**Identification cards — Recording  
technique —**

**Magnetic stripe — High coercivity —**

AMENDMENT 1:  $U_{i6}$  criteria and test  
method

#### AMENDMENT 1: $U_{i6}$ criteria and test method

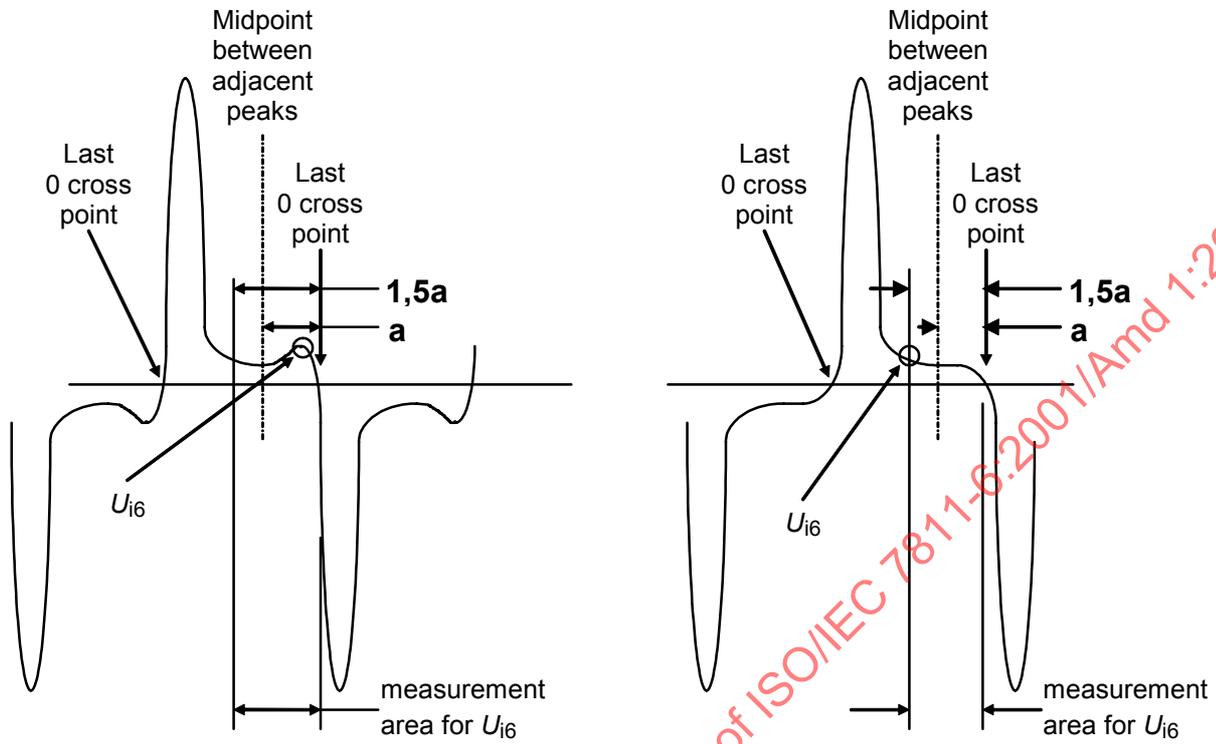
6. The algorithm defined in Figure 7 of ISO/IEC 7811-6 has been changed to produce more consistent results.

Replace the figure with the one shown below.

1.	Find midpoint between 2 adjacent peaks.
2.	Find 0 crossing point for waveform between midpoint and adjacent peak.
3.	The measurement area is 1,5 times the distance between the midpoint and 0 cross point.
4.	Find the largest signal amplitude level in the measurement area defined in the figure.
5.	The absolute value of this level is the $U_{i6}$ for the waveform.
